**Subject: Beaver Valley Power Station, Unit No. 1
Docket No. 50-334, License No. DPR-66
Unit 1 Capsule Y Revised Reactor Vessel Integrity
Database Information**

Attachment A

Capsule Y RVID Markups

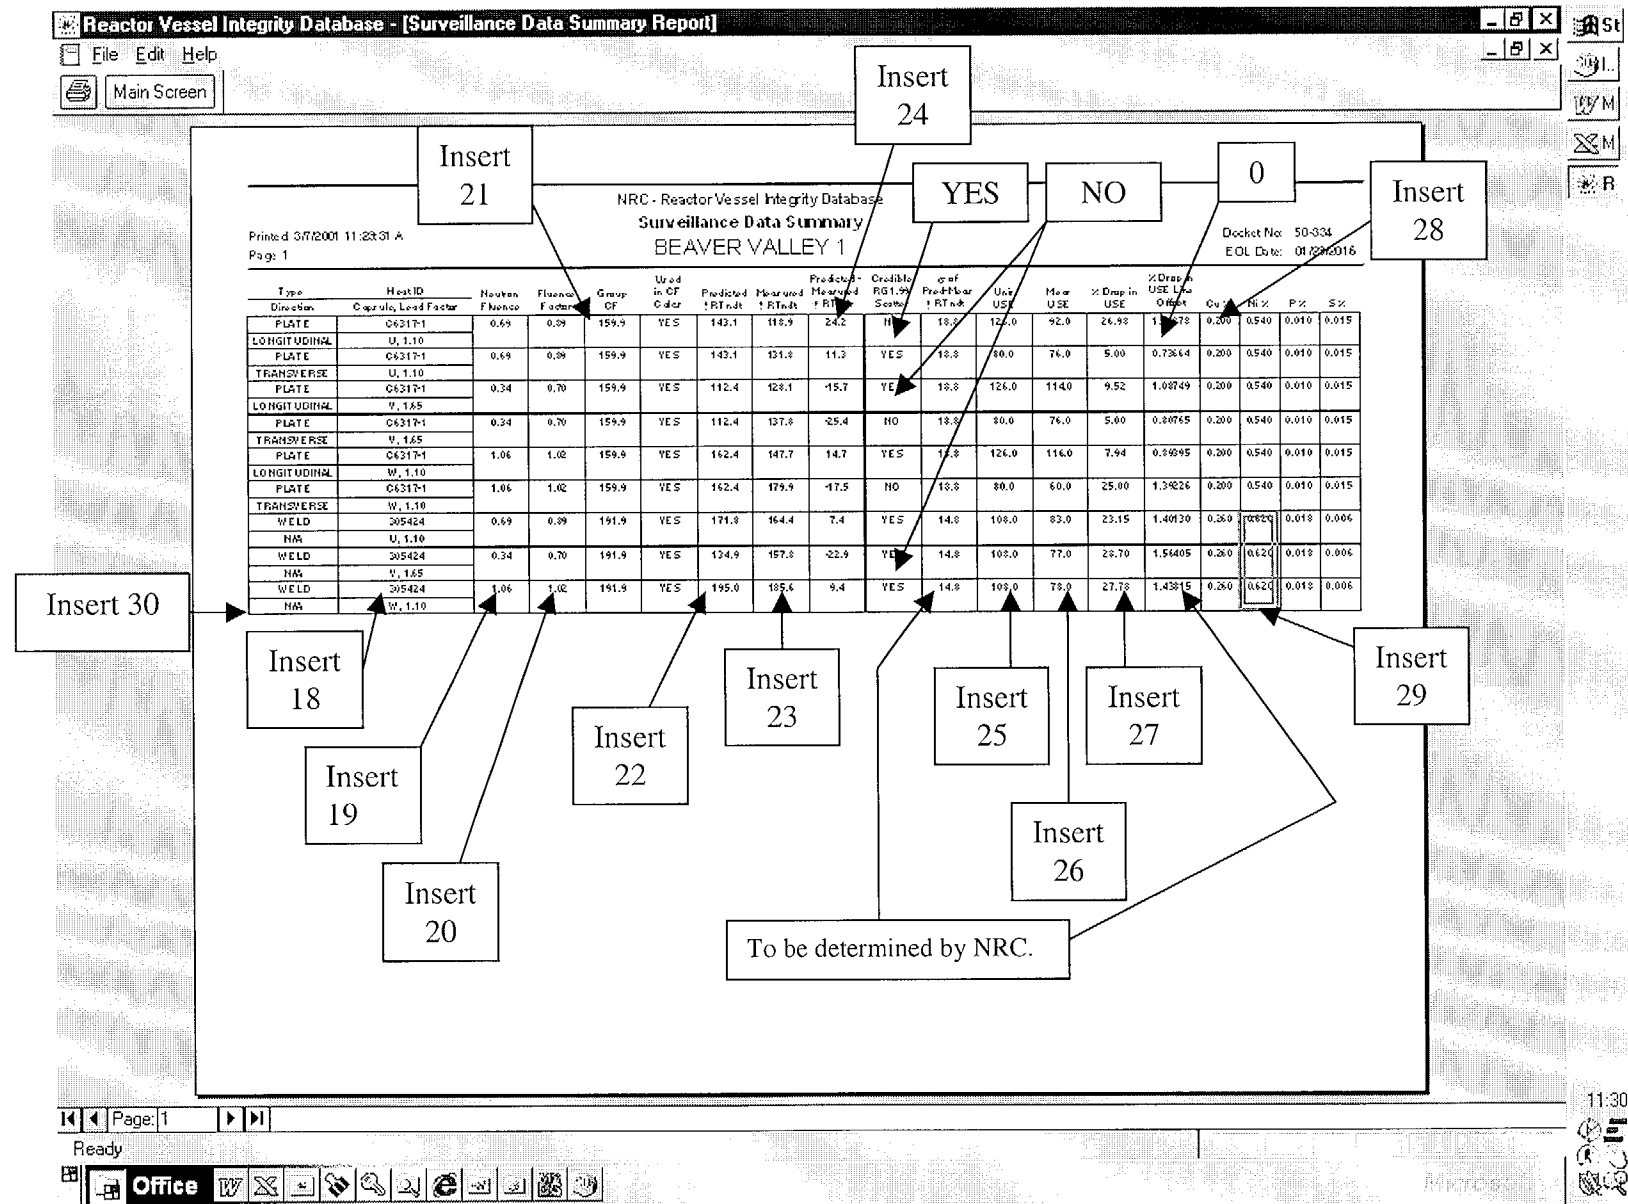
New information to be added to table.

PLATE	C6317-1	2.15	1.21	147.2	YES	178.1	142.18	35.92	NO		135	110	25		0.21	0.54	0.01	0.015
LONGITUDINAL	Y, 1.22																	
PLATE	C6317-1	2.15	1.21	147.2	YES	178.1	166.93	11.17	YES		81	71	10		0.21	0.54	0.01	0.015
TRANVERSE	Y, 1.22																	
WELD	305424	2.15	1.21	181.6	YES	219.7	179.69	40.01	NO		112	77	35		0.26	0.61	0.08	0.006
N/A	Y, 1.22
